Environmental Review Team  
Report  
on  
**Stonington Land Company**  
North Stonington Connecticut  
February 1979

STONINGTON LAND COMPANY SUBDIVISION  
NORTH STONINGTON, CONNECTICUT

ENVIRONMENTAL REVIEW TEAM REPORT  
ON  
STONINGTON LAND COMPANY SUBDIVISION  
NORTH STONINGTON, CONNECTICUT

# Preliminary Subdivision Plan

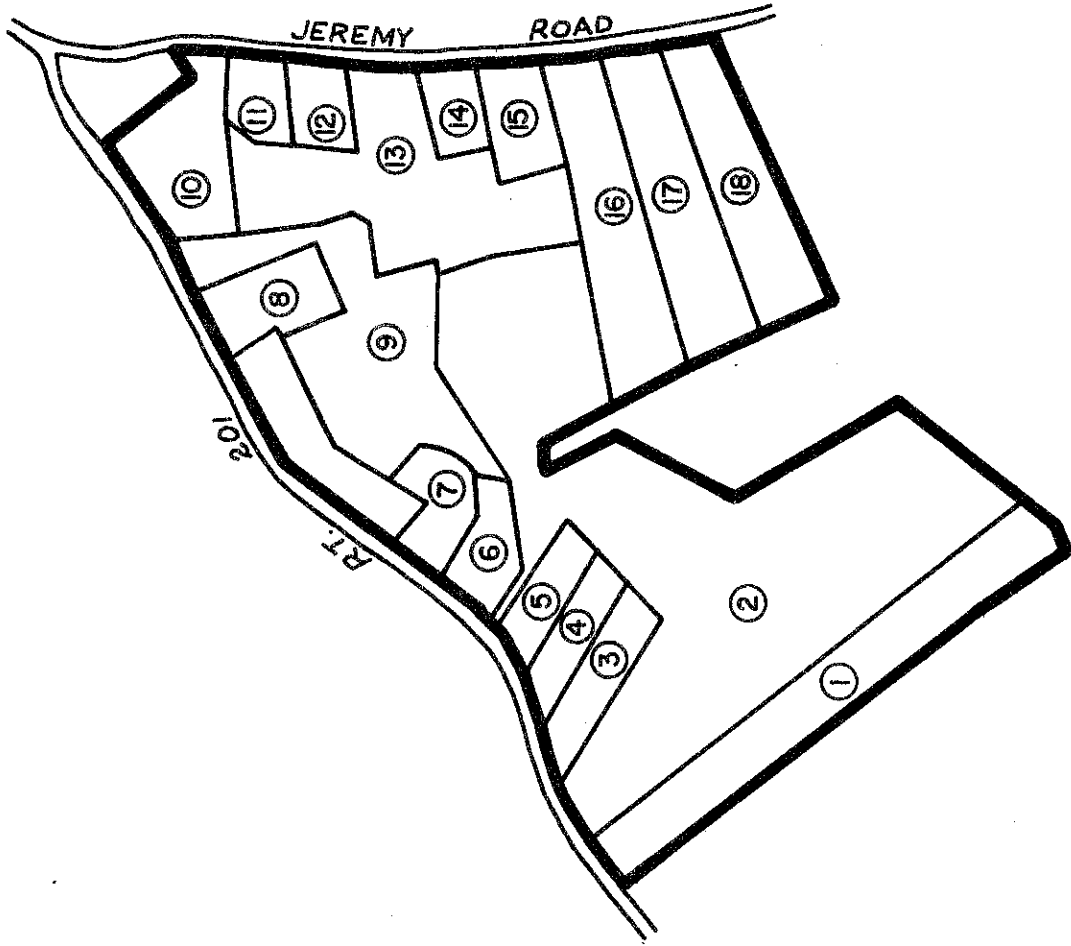
The Team is concerned with the effect of this land use proposal on the natural resource base of this site. Examination of soils data before the field review and at the site reveal problems which may exist with foundation development on lots 8, 10, 14, 15, 16, 17, and 18, and with establishment of septic systems on lots 3 through 7. These problems relate to soils with seasonally high water tables and shallow-to-bedrock soils, respectively. Due to the number of wetland soils and open watercourses on the site, a sediment and erosion control plan should be implemented during construction on each individual lot. Conformance to current frontage requirements of the Town Zoning Ordinances may cause problems for the present proposal. A provision for open space also does not appear on the plan.

A potential solution to some of these problems could be reached by designating lots 1 and 2 as open space land. Combining lots 8 and 10 with other adjacent lots would be in the best interest of prospective buyers and the natural resource base of the site due to the wet soil conditions. Also, due to the travel conditions of Route 201 and Jeremy Hill Road, the Team Planner suggests that lots contain a road-improvement easement for future upgrade of these roads with increased traffic demands.

The North Stonington Zoning Regulations require a front yard width of 200 feet in the R-R District. The front yard is defined as the "space extending for the full width of the lot between the front line of the nearest building wall and the front lot line." It does not appear that this requirement can be met for lots 2, 3, 4, 5, 7, 8 and 9 in the layout presently being considered.

The proposed plan also makes no provision for open space in the subdivision, although North Stonington's regulations require that 5% of the tract be devoted to this purpose and not more than half of the open space can be wetlands or slopes greater than 5%.
